VTP CONSULTATION RESPONSES

VTP TECHNICAL NOTE – SPINE ROAD SUITABILITY ASSESSMENT

1.1.3 The Proposed Firethorn Development description for the outline planning application, planning reference: 21/01630/OUT, is as follows:

Figure 4-3: Bridge Crossing of Charlotte Avenue

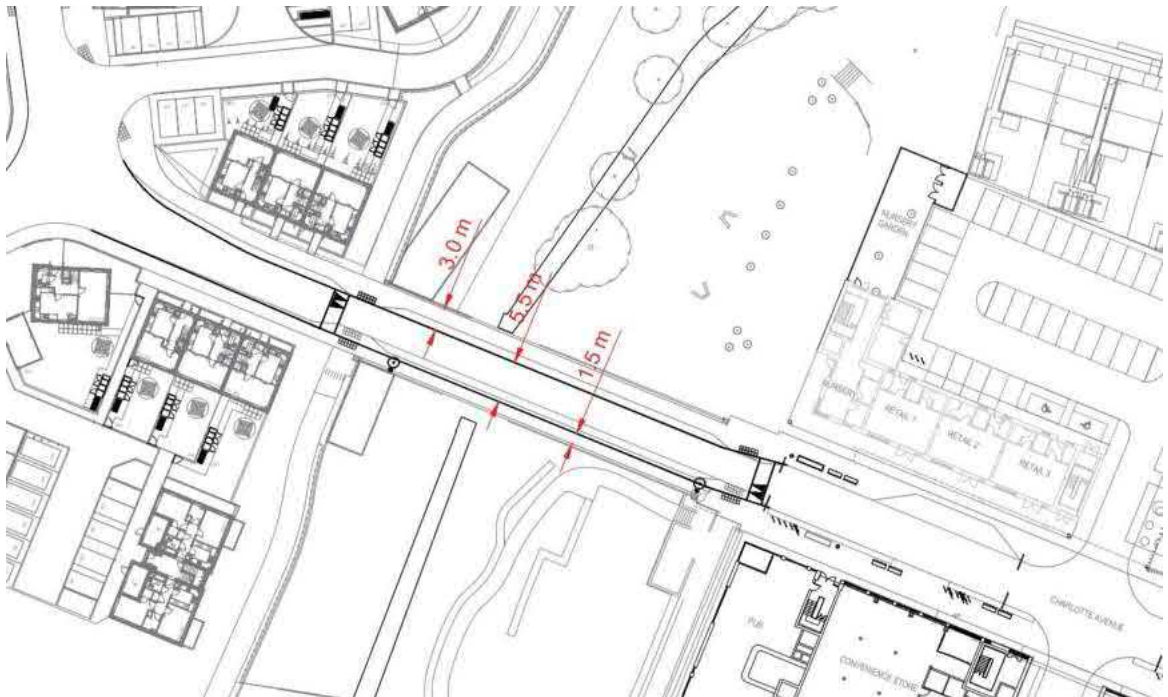
4.3.5 It is noted that the existing width across the key constraint. i.e. the bridge on Charlotte Avenue, is in the order of 10.0m. Existing footways of approximately 2.0m are provided on either side of the bridge and the road narrowings at either end of the bridge reduce the carriageway width of Charlotte Avenue to 4.1m. As such, the general carriageway width across the bridge and between the road narrowings either side of the bridge is approximately 6.0m.

4.3.7 Figure 4.1 of LTN 1/20 recommends that for carriageways that accommodate 6,000+ vehicle movements per day, a cycle lane should be provided to accommodate the majority of cyclists. Table 6-3 of LTN 1/20 recommends that for shared routes that accommodate up to 300 pedestrians per hour and up to 300 cyclists per hour, a width of 3.0m should be provided for a segregated shared route. If these figures are exceeded for a shared route, then the recommended width is 4.5m.

4.3.6 VTP Drawing **4600-1100-T-029 Rev A** – Bridge Footway Provision proposes a physical improvement to the layout of Charlotte Avenue across the bridge to introduce a ‘segregated footpath/cycleway’. The full plan is included at **ATTACHMENT 4** of this TN and **Figure 4-3** presents an extract from this.

- 4.3.10 By introducing the 3.0m wide shared footpath/cycleway on the northern side of the bridge and a narrow 1.5m footway on the southern side of the bridge, the remaining carriageway width would be 5.5m. This is considered to be an acceptable width for two-way traffic flows. Figure 7.1 of Manual for Street (MfS) notes that a width of 5.5m can accommodate two HGVs passing each other, which is considered to be a rare requirement for the Spine Road as no through traffic is expected to use this route.

- 4.3.12 The VTP proposals show how the amendments to the bridge crossing might tie into the existing Spine Road without the need for substantial highway works and no disruption to the built development.

Areas in Red Show footway less than 2m wide

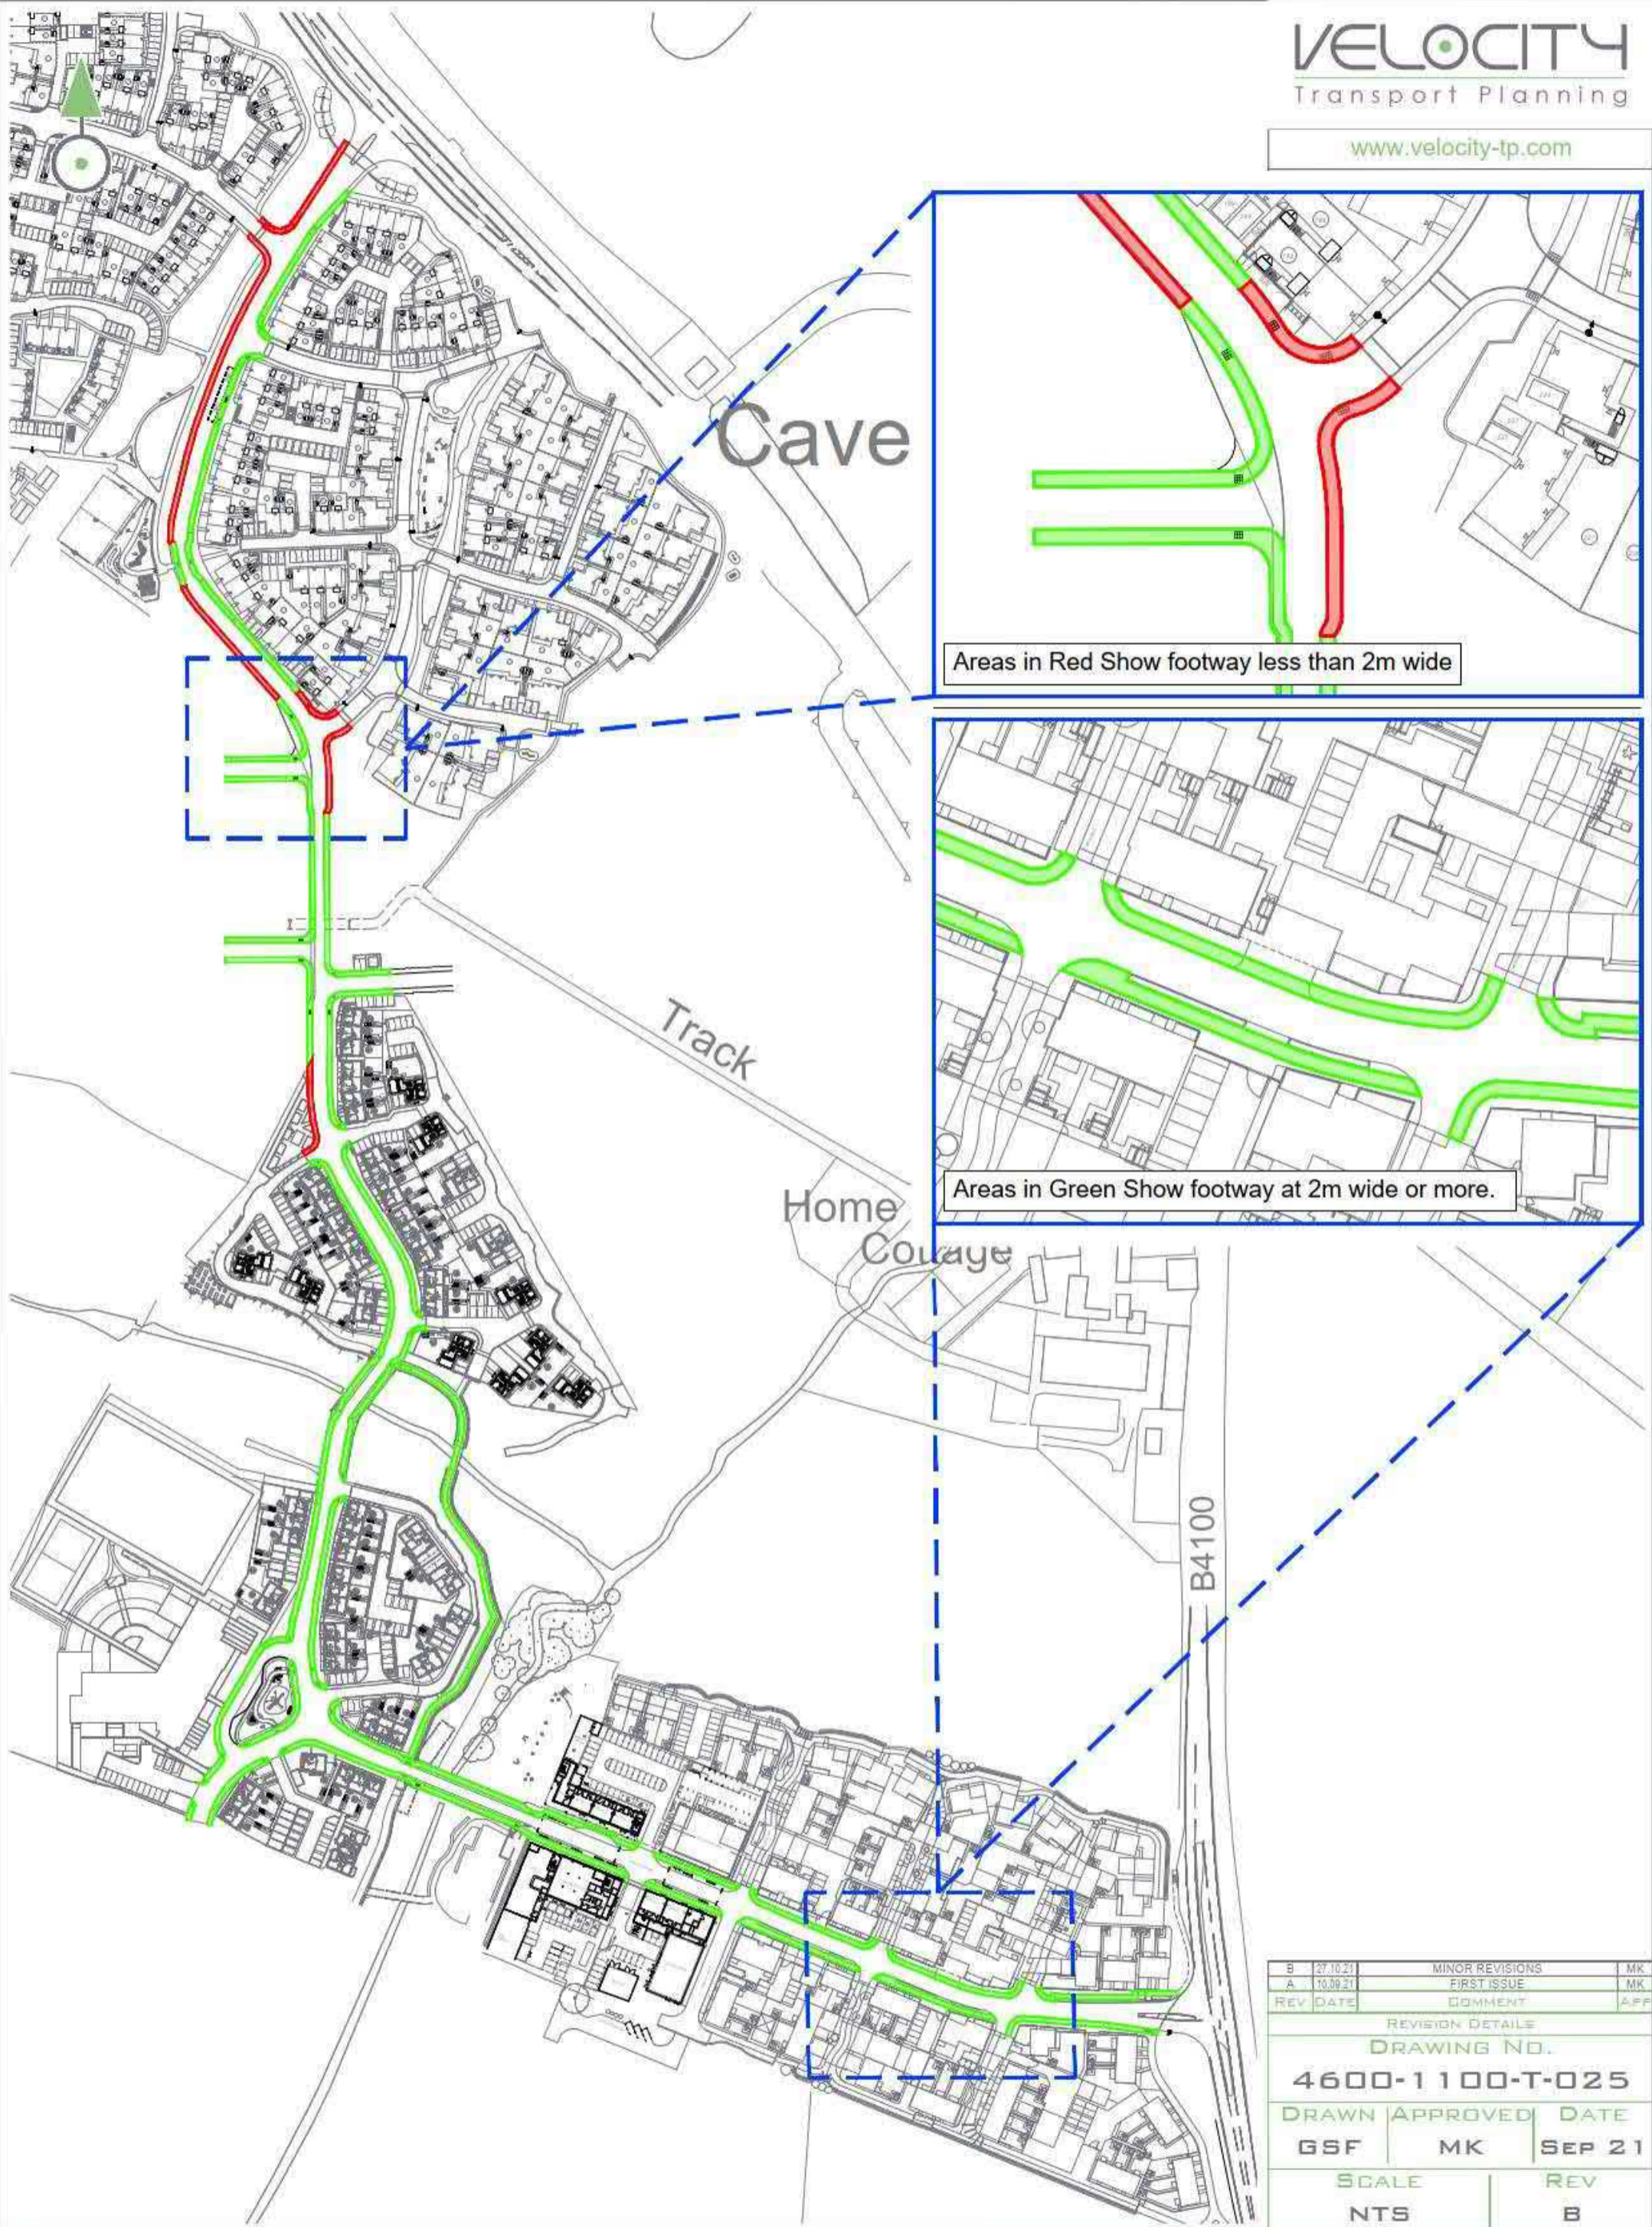
4.1.6 VTP Drawing **4600-1100-T-025 Rev B** – Spine Road Footway Detail, a copy of which is included at **ATTACHMENT 4**, demonstrates that the majority of the footway widths are in excess of 2m.

- 4.2.8 It is also noted that there are alternative routes available via side streets and the dedicated link between the two bridges on Charlotte Avenue that effectively bypasses the Gagle Brook Primary School. This link is presented on the VTP Drawing **4600-1100-T-025 Rev B**, a copy of which is contained at **ATTACHMENT 4**.

Title:
Proposed Development
Agreed Distribution Profile (Including updated distribution at Junction 9)

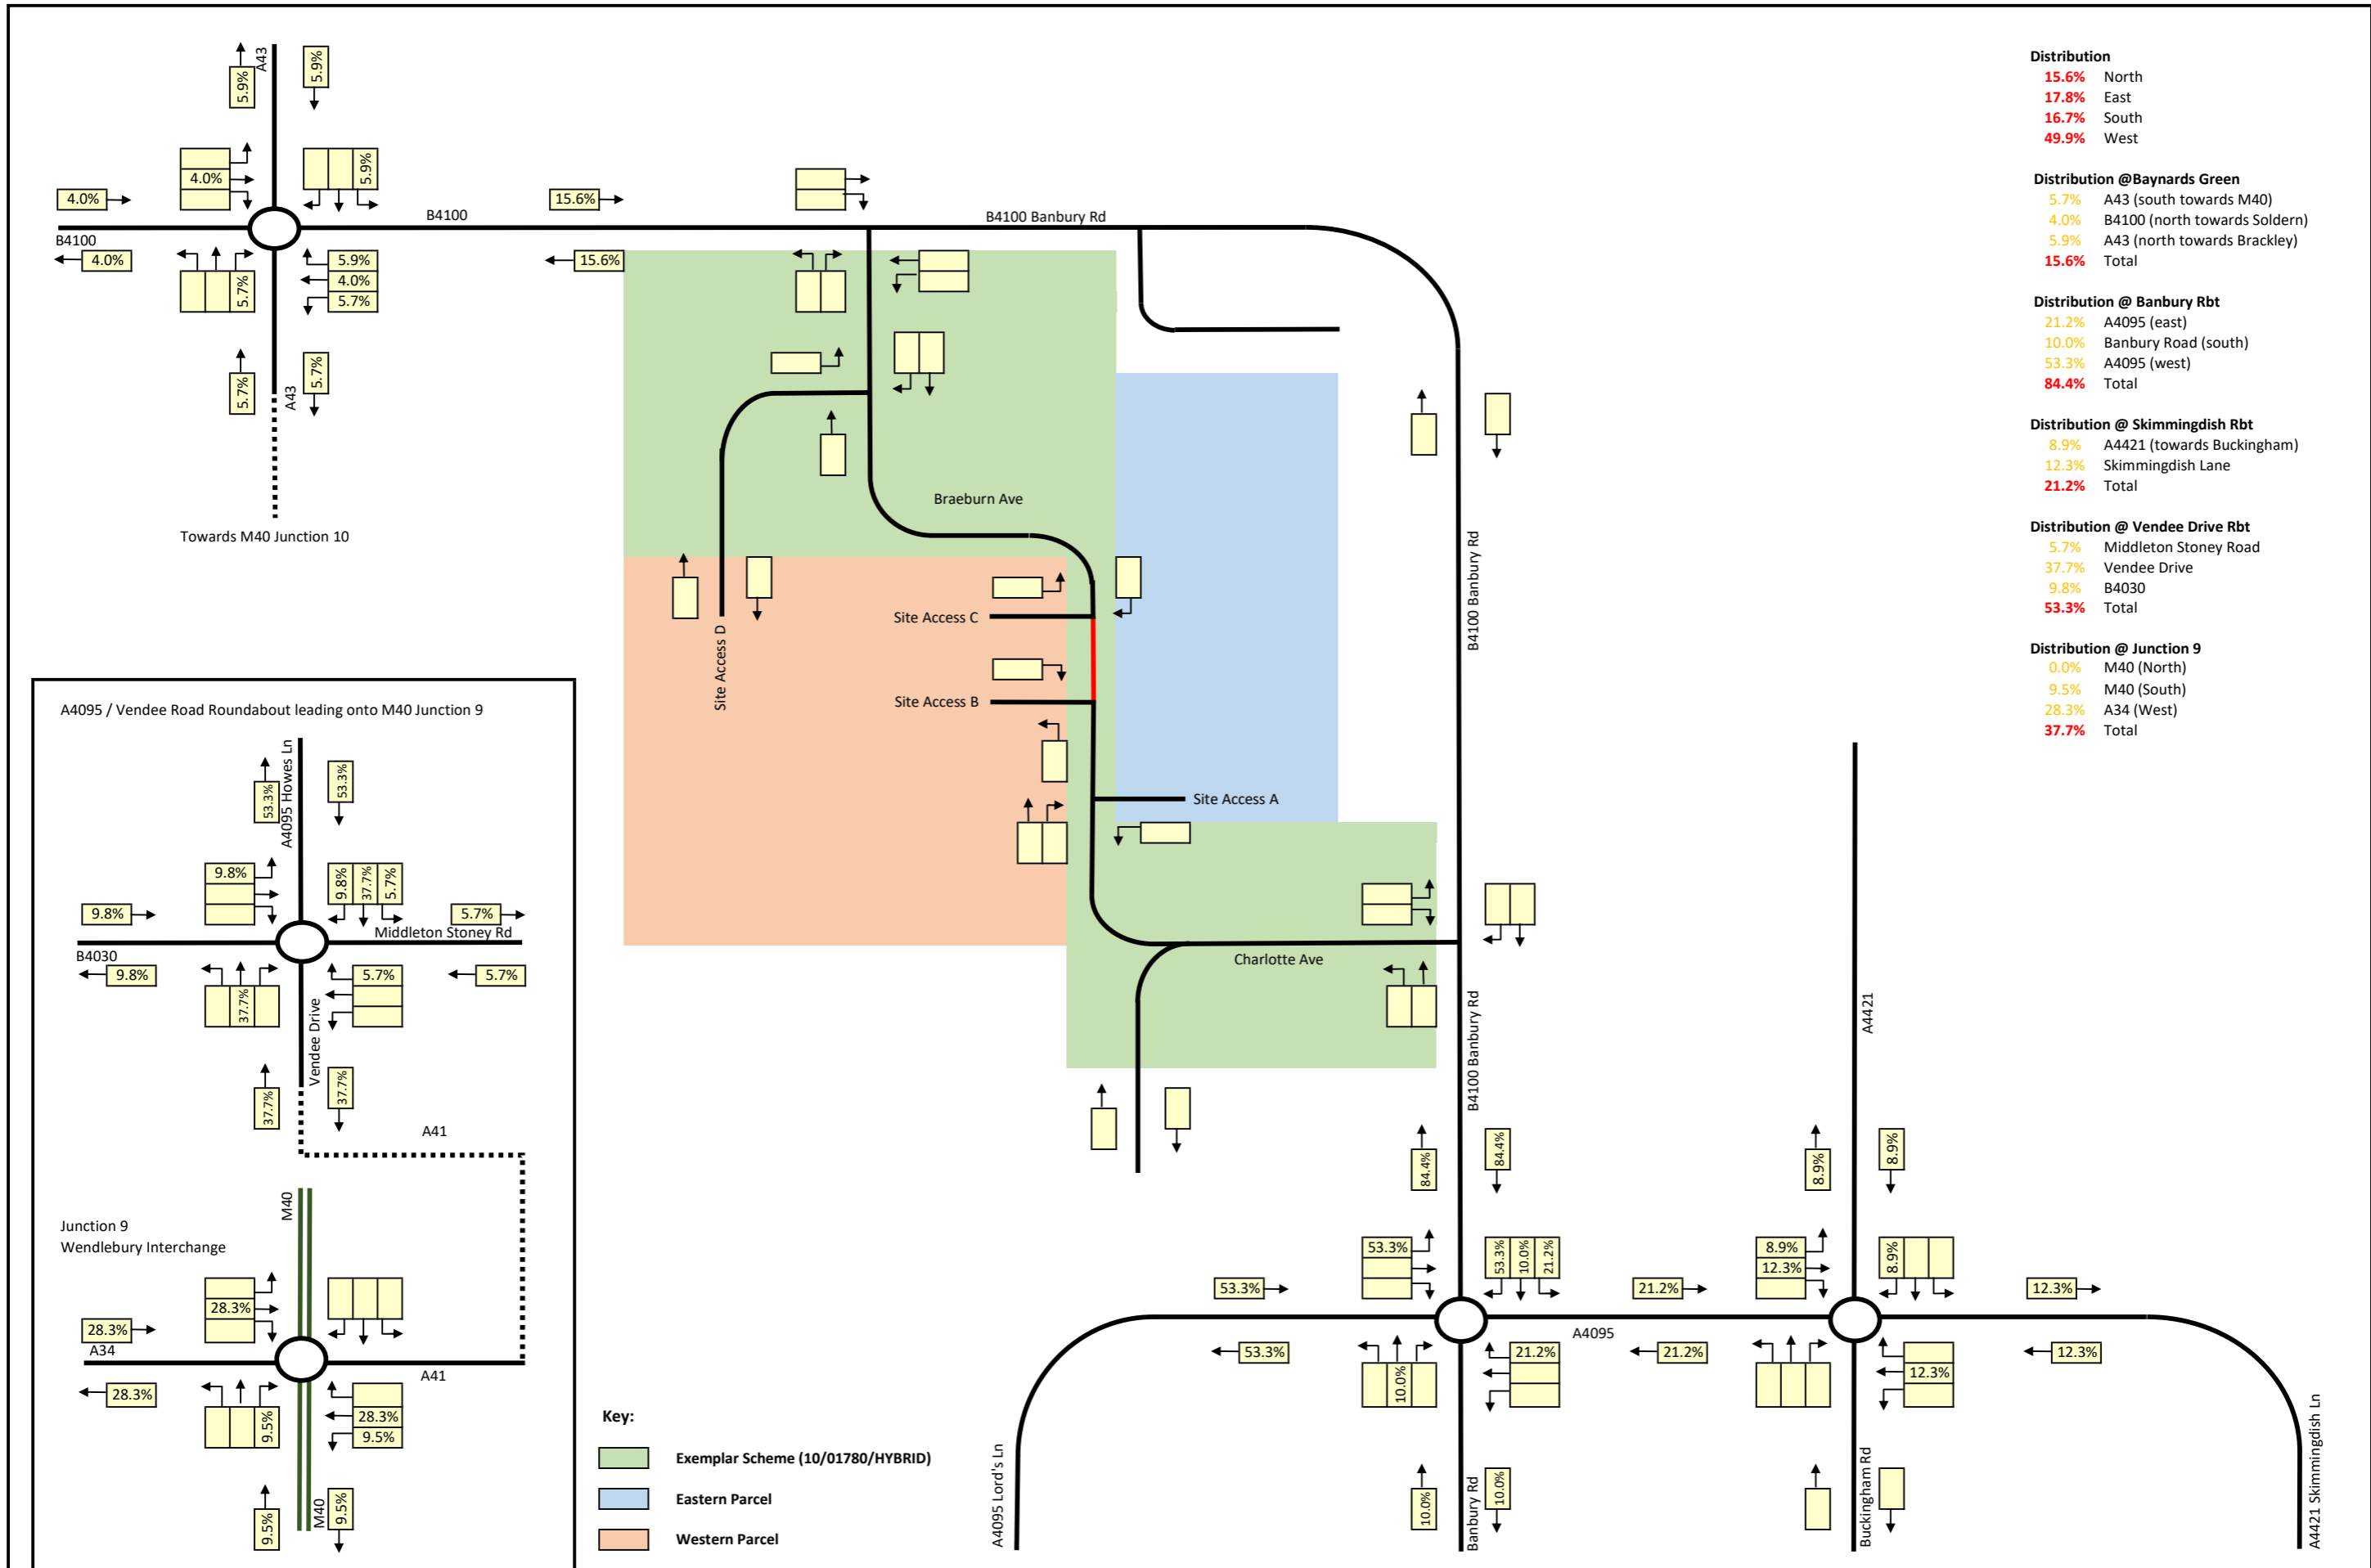
The impact of the development is not shown south at Junction 9 of the M40, development flows can be seen to travel south on the B4100, A4095 and subsequently Vendee Drive towards this junction but no further distribution is provided in the diagrams nor mentioned in the text. The highest flow shown being +83 southbound in the AM peak on Vendee Drive. We are content with the trip generation and distribution methodology, however more information is required to show the traffic impact and distribution at Junction 9 of the M40.

Further to our recent telephone discussion and your email below requesting further clarification on the assumptions regarding traffic flows associated with the respective parcels at the Firethorn Development, I have provided a sketch plan that I trust helps clarify the position that I set out in my email dated the 14th of October 2021 (below).

Figure 1: Aunt Em's Lane Connection (taken from Fig 5.3 of Appendix 6.2)

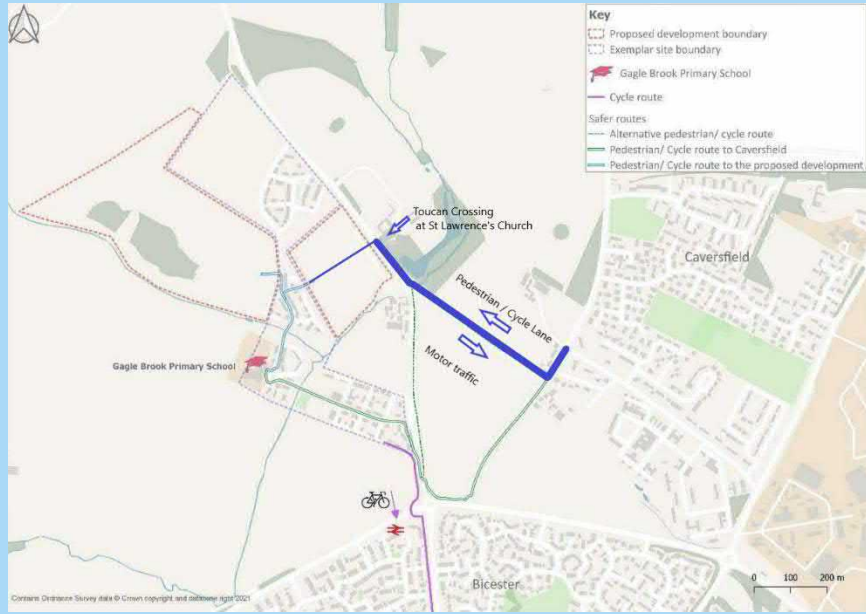
In order to connect to neighbouring communities, active travel links to the site via Aunt Ems Lane (the lane between the B4100 and the Fringford Road) should be included in the plans. BicesterBUG rejects the notion that the Fringford road offers a suitable route, as outlined above. We reiterate that one low cost possibility would be to provide a dedicated active travel corridor between NW Bicester and Caversfield by closing Aunt Ems Lane to motor vehicle traffic. We note that the developer has assessed the connection (in ES vol 2 Appendix 6.1 and 6.2 Transport assessment), we disagree with the assessment and contend that with minor changes suitable active travel provision can be constructed. The reasoning that the existing route via skimmingdish lane is shorter than an alternative via Aunt Em's lane and the east development parcel (e.g. via Home Farm) is not proven

Alternatively, Aunt Ems Lane could be made one-way for motor traffic from the B4100 to the Fringford Road to maintain access, allowing the current E-Bound lane to be segregated into a bi-directional active travel route. This option would provide safe access between the proposed development, Caversfield, the church and the school. The addition of a path along the eastern side of the B4100 from aunt em's lane to St Lawrence Church and a crossing to the proposed development site would make a valuable addition to the active travel connectivity of the development and the wider area. This would unlock active travel access to the church which is currently not possible from Elmsbrook or Caversfield.
